ADDENDUM NO. 03

PROJECT: Ossining Union Free School District
2024 Bond: Phase 1
OHS Locker Room & CTE Addition

CPL PROJECT NO. R24.16761.00

DATE: May 21, 2026

8 REHEAT COIL DETAIL
H800 NOT TO SCALE

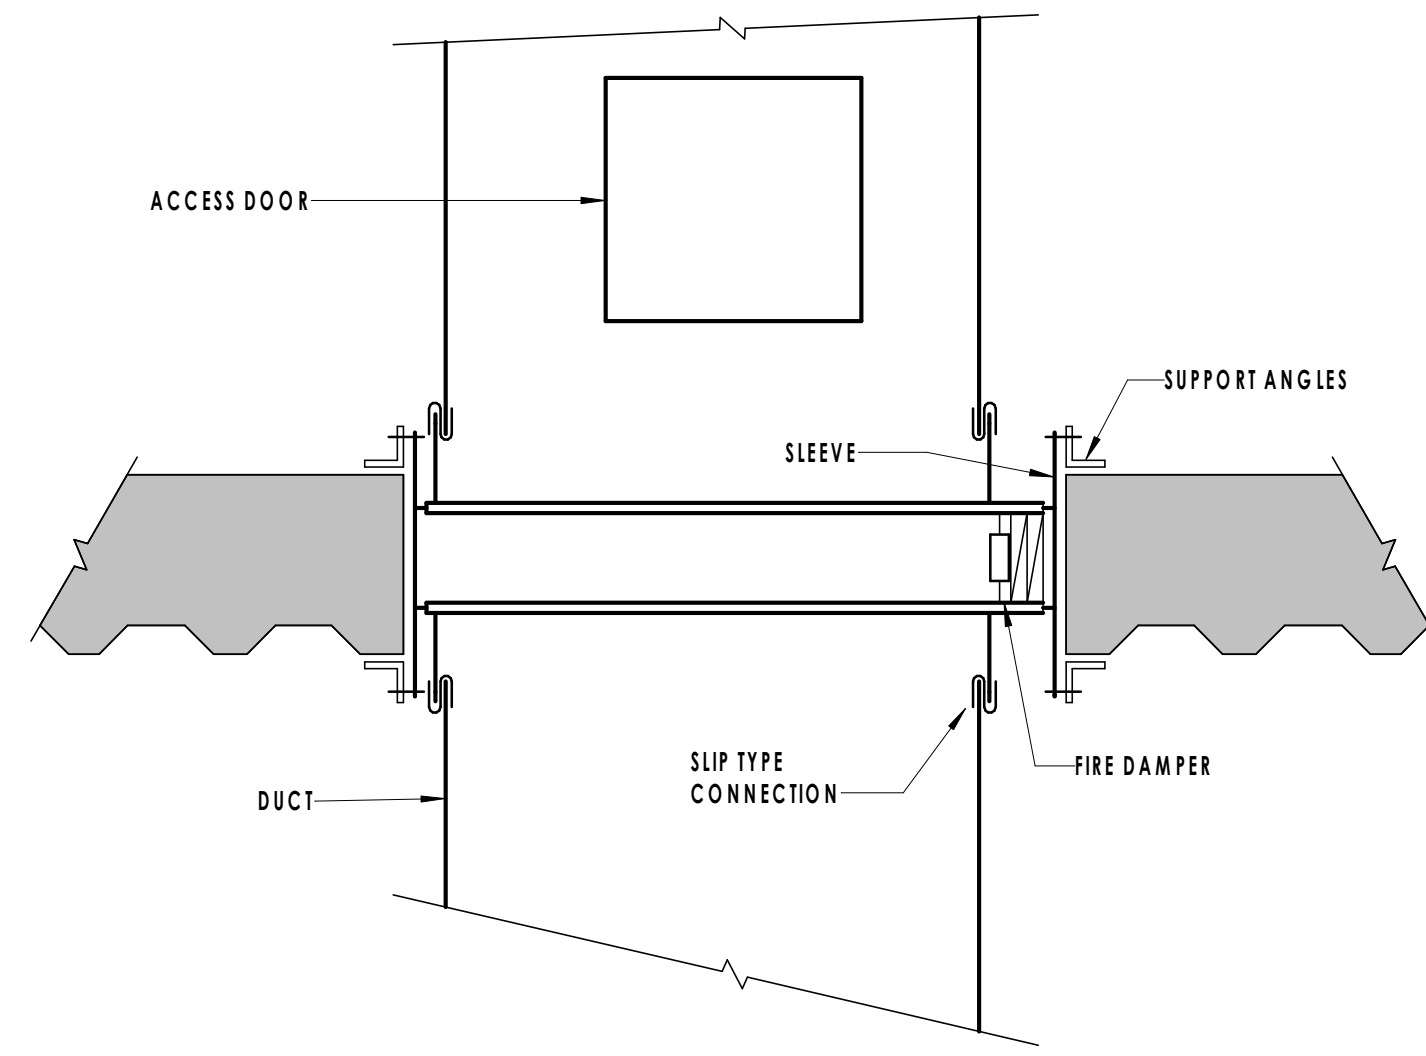
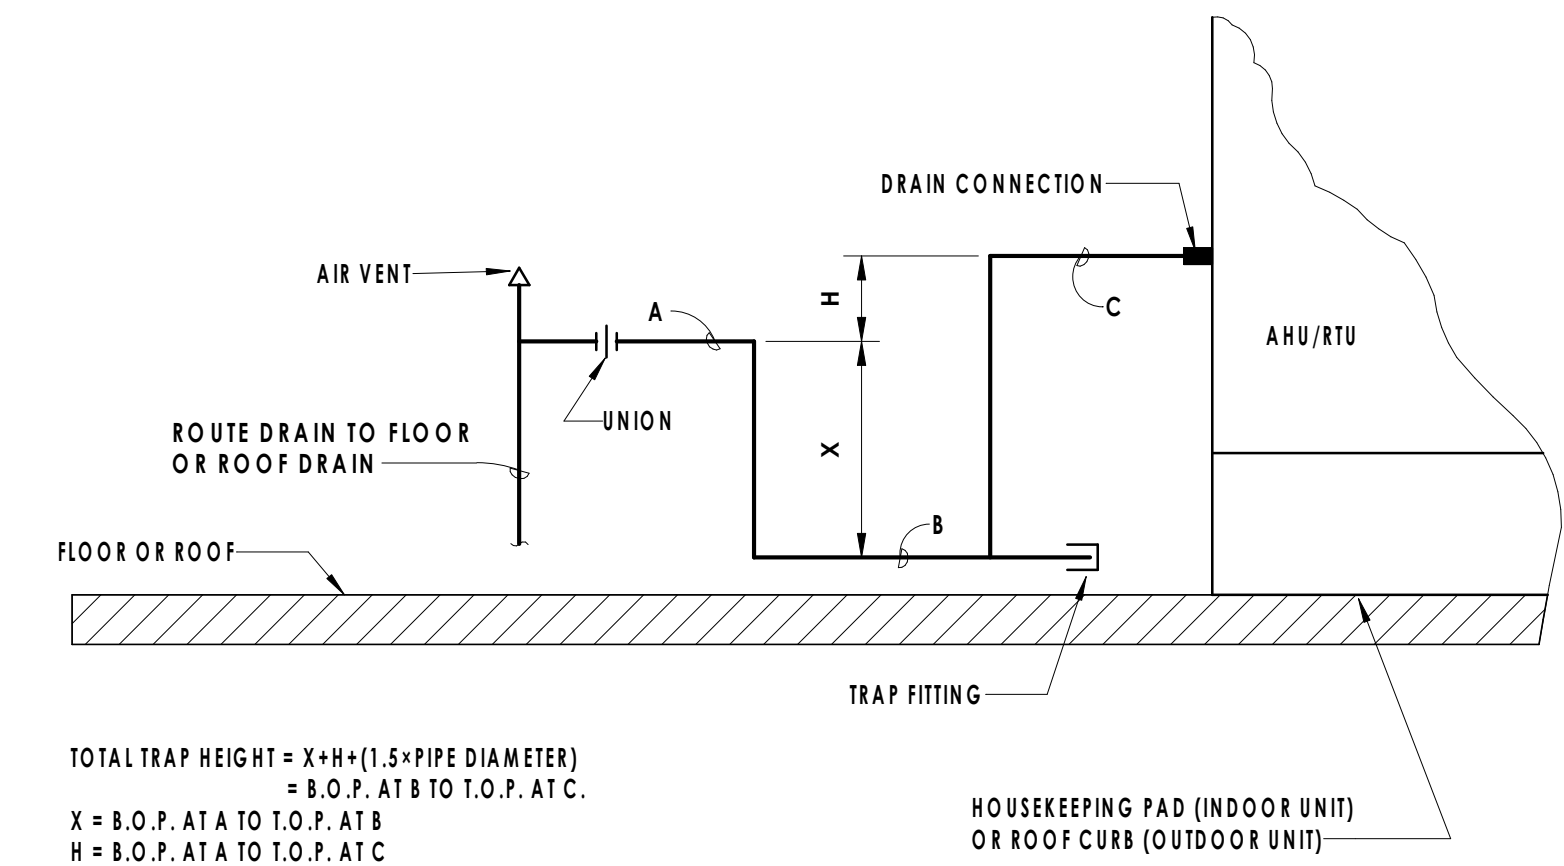
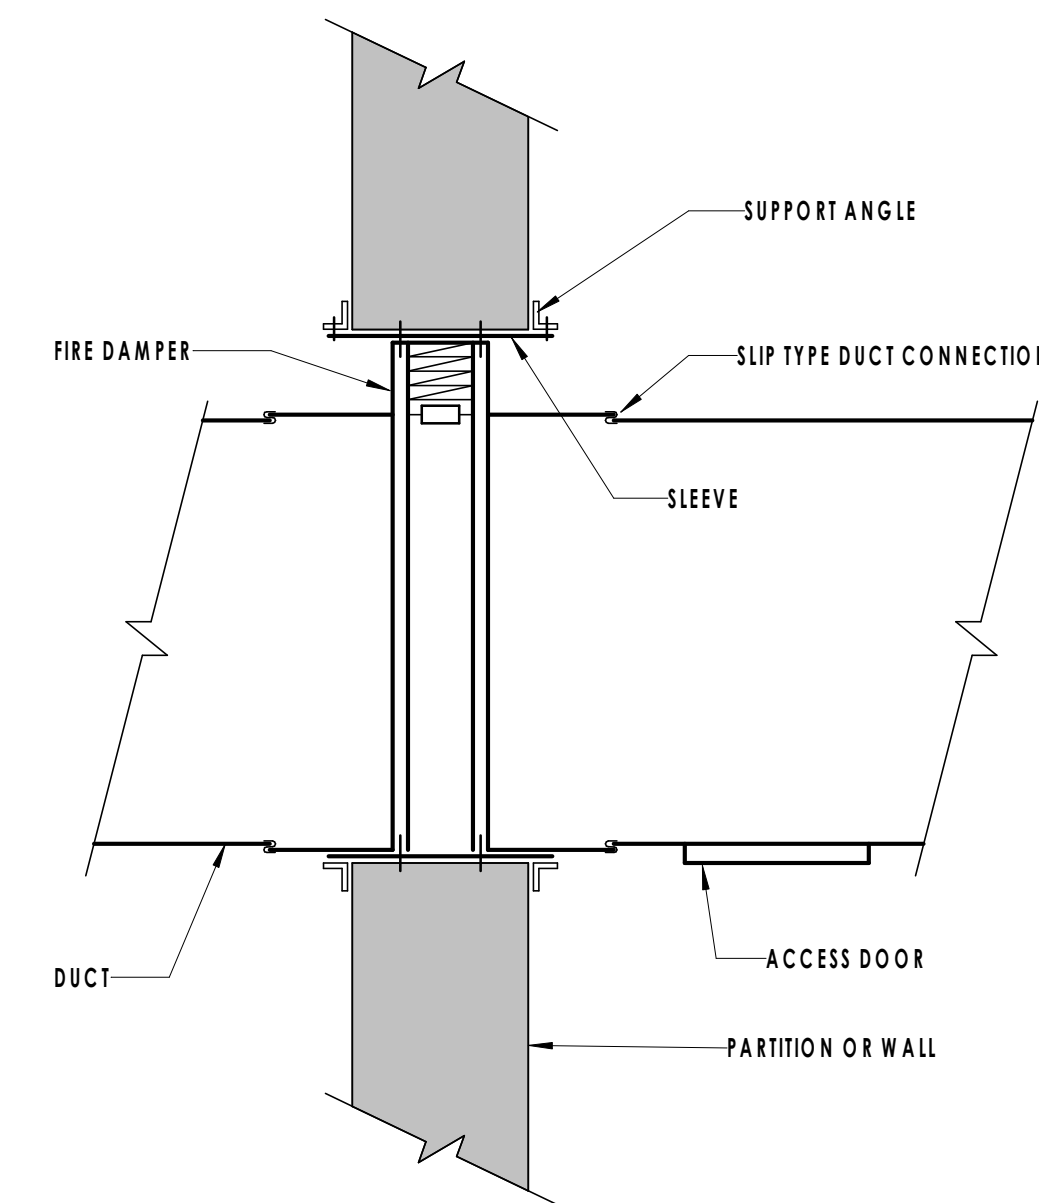
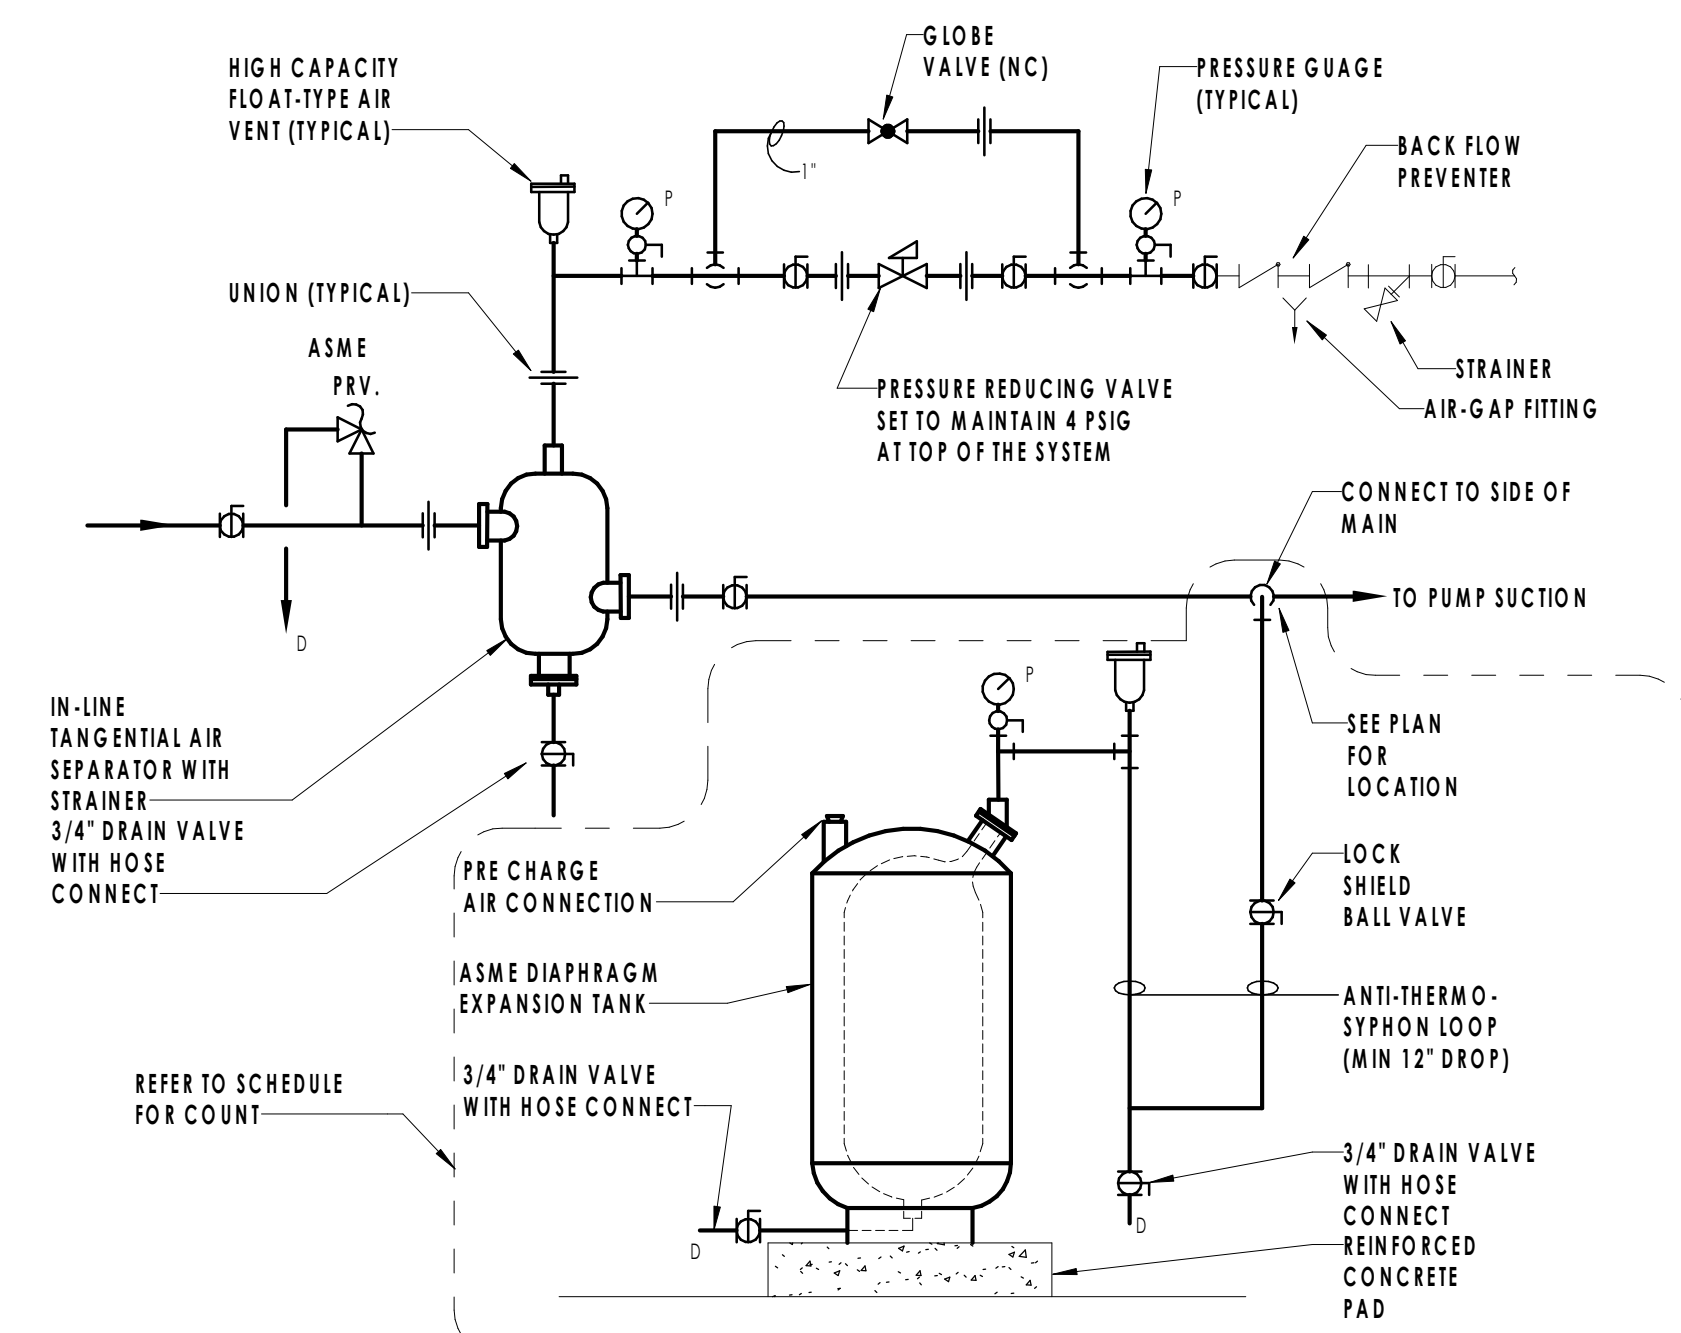
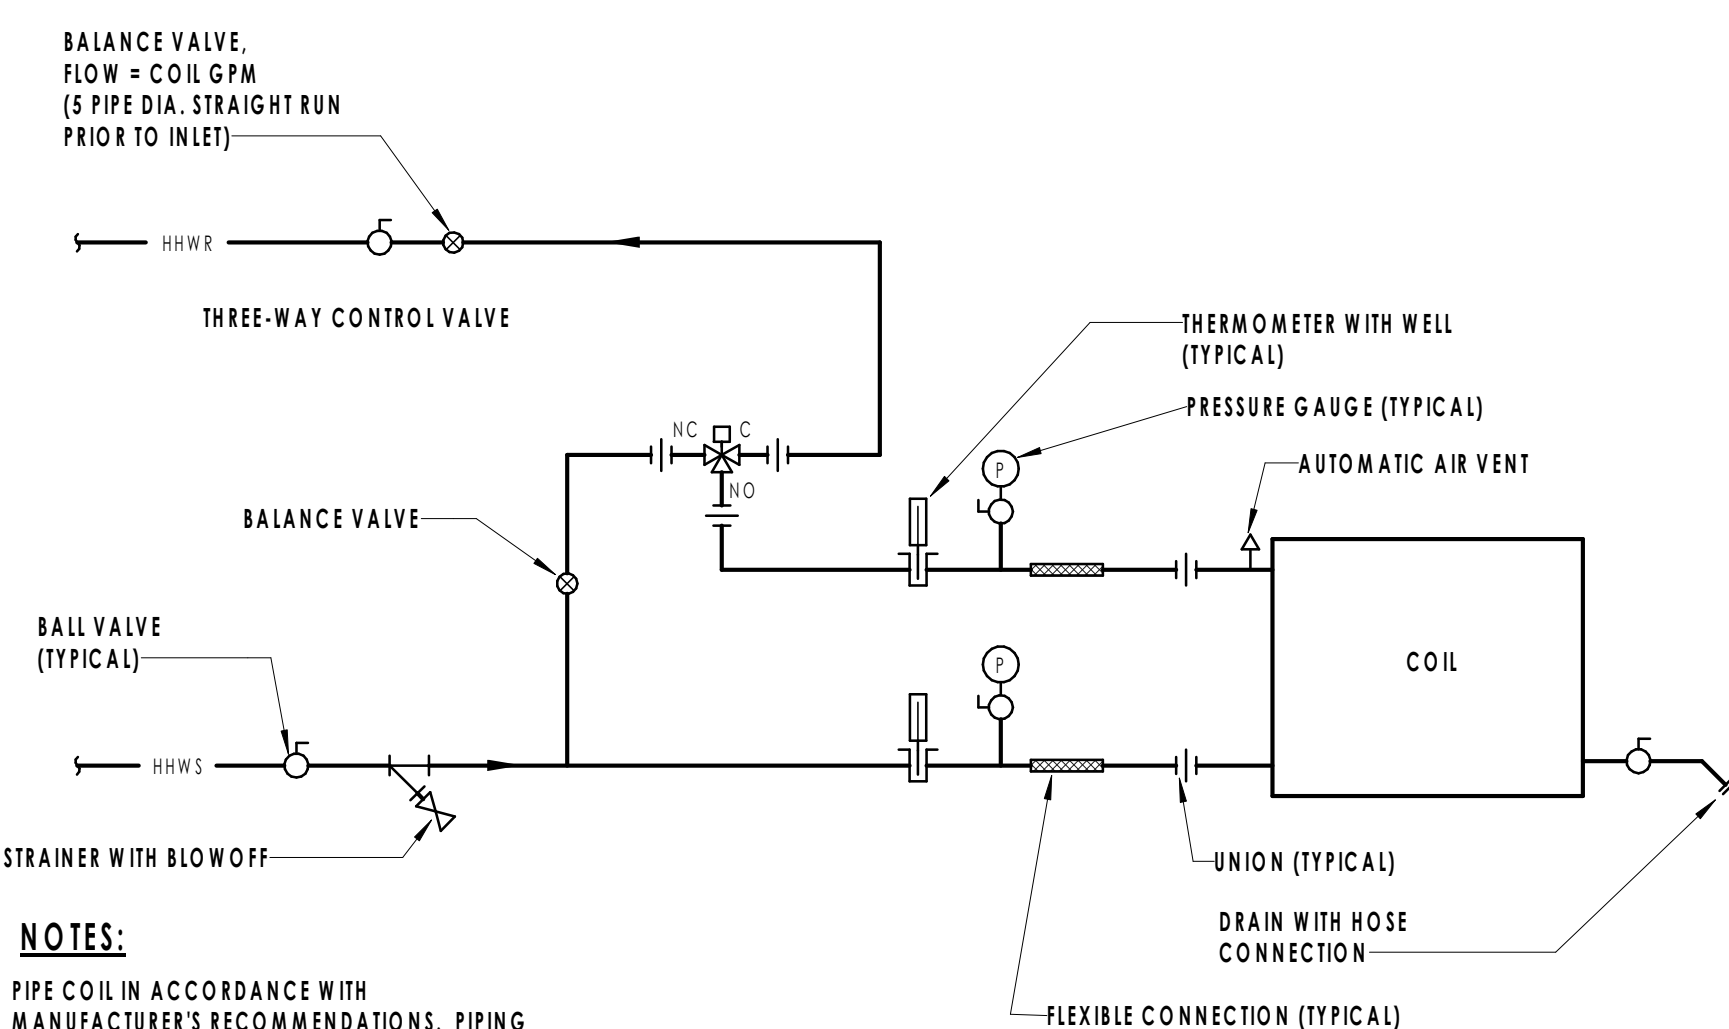
1.3 Question: There does not appear to be a detail indicating the trim requirements for the blower coils and ducted heating coil. The also does not appear to be a control valve listed on the CUH/UH detail. Please clarify.

Answer: See revised H800 and H500 drawings
